VEHICLE INTERIOR AIR QUALITY (VIAQ) TEST PROCEDURES & PROPOSAL

30 March 2016

KATRI, The Republic of KOREA
(Korea Automobile Testing & Research Institute)

VIAQ Test Procedures & Proposal

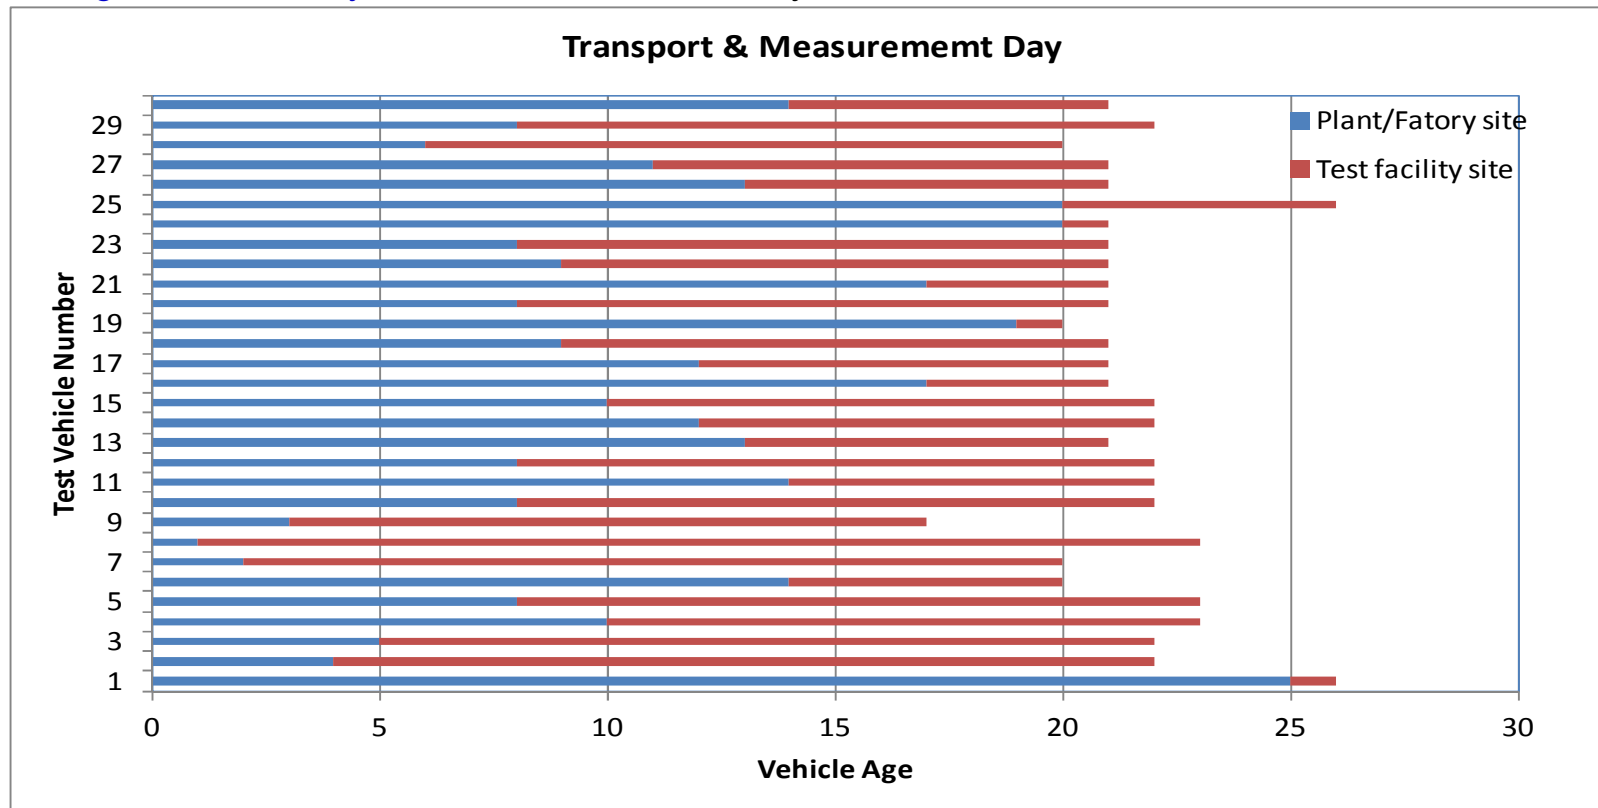
- ◆ Vehicle age at testing date: 28 days \pm 5days after the production date.
- ✓ Check tests is possible after production that means everything to be ready for customer.
However , due to VOCs characteristics, not have testing chamber in all plants, need to be transition period
- ✓ Storage in Factory or motor pool(PDI) : Day 0 ~ Day X (min.1 ~ max. 25)
- ✓ Storage in Test facility : tested within 14 ~ 28 days

VIAQ Test Procedures & Proposal

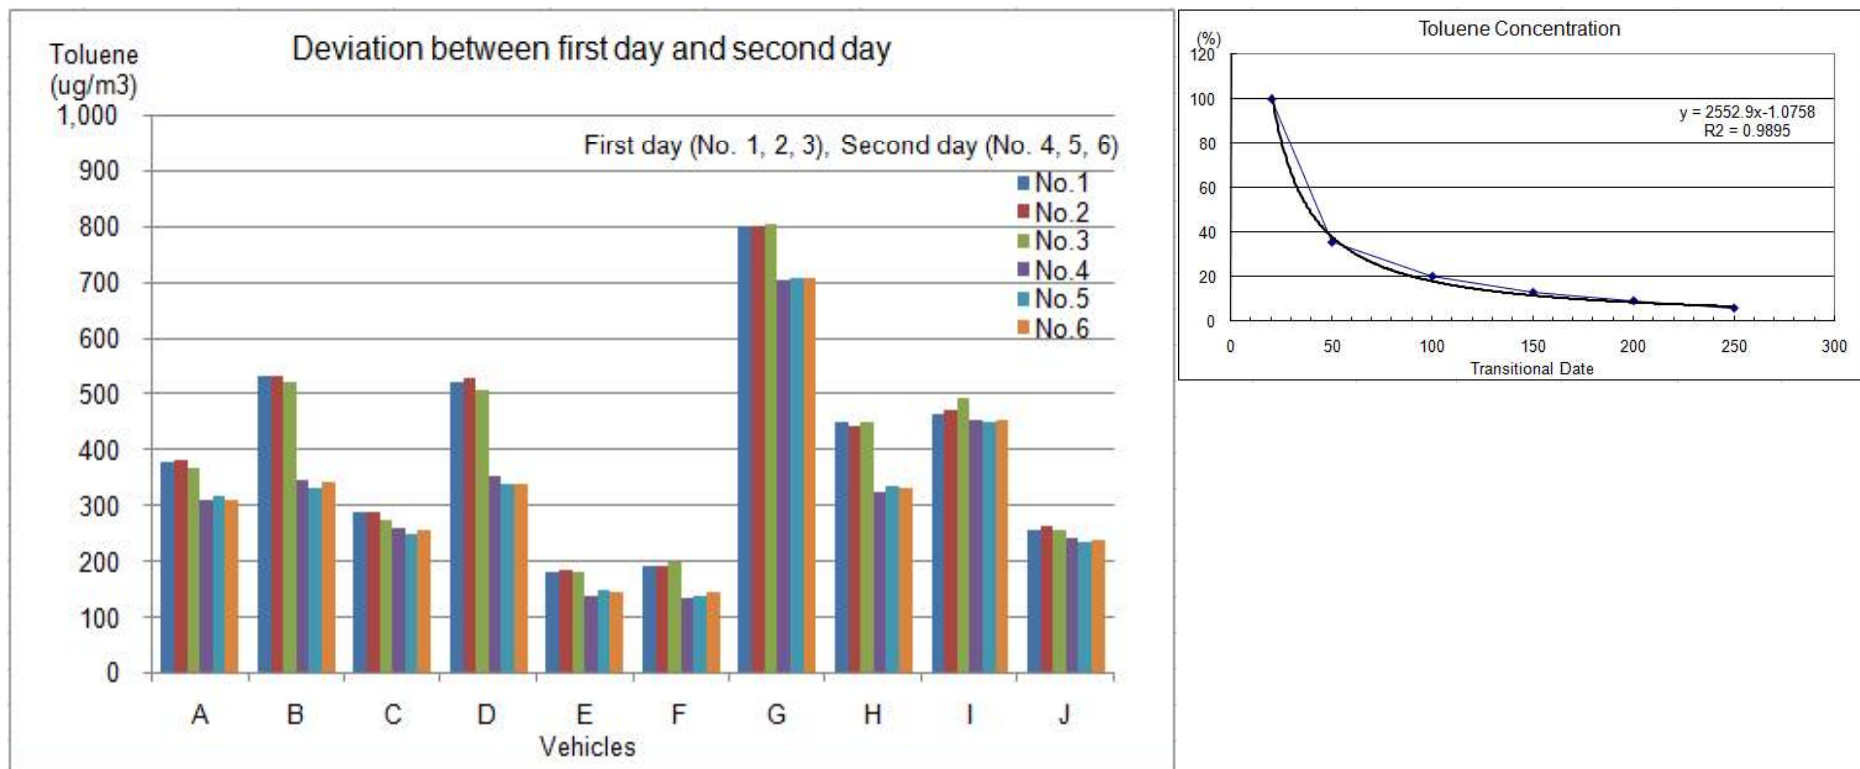
- ◆ Vehicle age at testing age: 28 days \pm 5days after the production date.
- Regarding the 5 day margin, the age of the vehicle at measurement should be 28 days, or as close as possible to 28 days, because the difference of 10 days could result in high variability in the test results. If it is not 28 days, it can be documented with the reason.
